New Albany Architectural Review Board Agenda
Monday, April 11, 2022 7:00pm

ARB-39-2022 Certificate of Appropriateness

Certificate of Appropriateness for a new wall sign for Fifth Third Bank at 155 E. Main Street (PID: 222-000231).

Architectural Review Board Staff Report January 10, 2022 Meeting

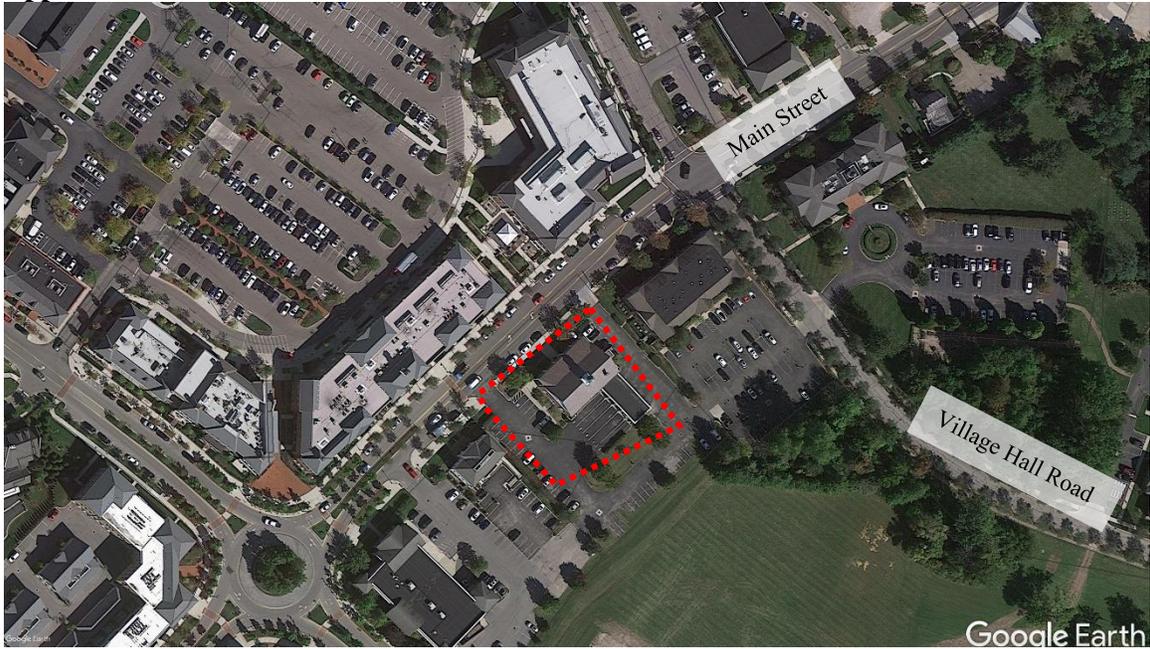
IV. RECOMMENDATION

Staff recommends approval of this application provided that the ARB finds that the proposal meets sufficient basis for approval. The proposed wall sign is appropriate for the building that it is located on and is appropriately designed to match the scale of the site and building.

BEFORE

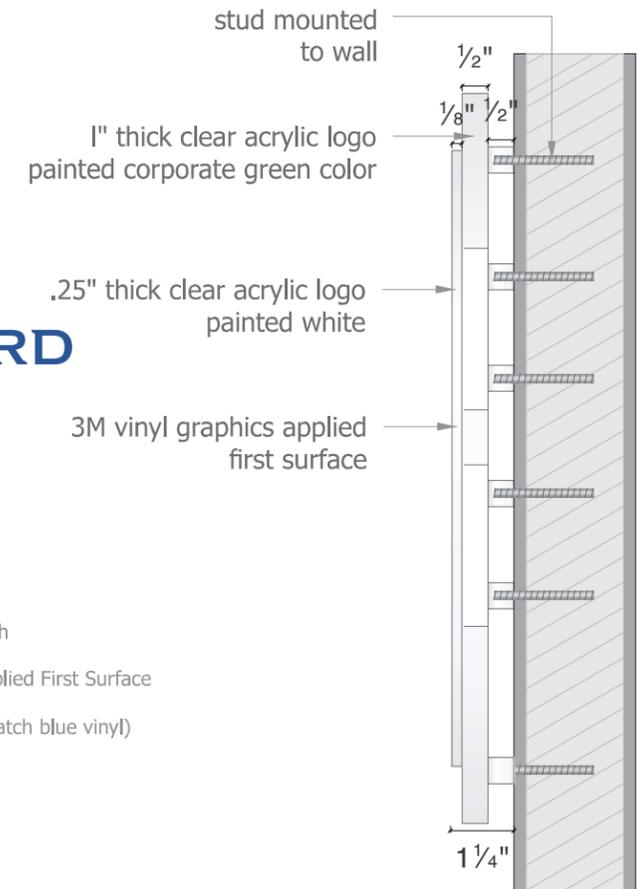
- REMOVE ALL OLD LETTERING
- FILL ALL HOLES WITH SEALANT
- PAINTING BY OTHERS
- INSTALL NEW STUD MOUNTED LETTERS
- OVERALL SIZE: 96.625" X 25.0625" = 16.8 SQ FT
- EXISTING SQ FT: 13.5 SQ FT
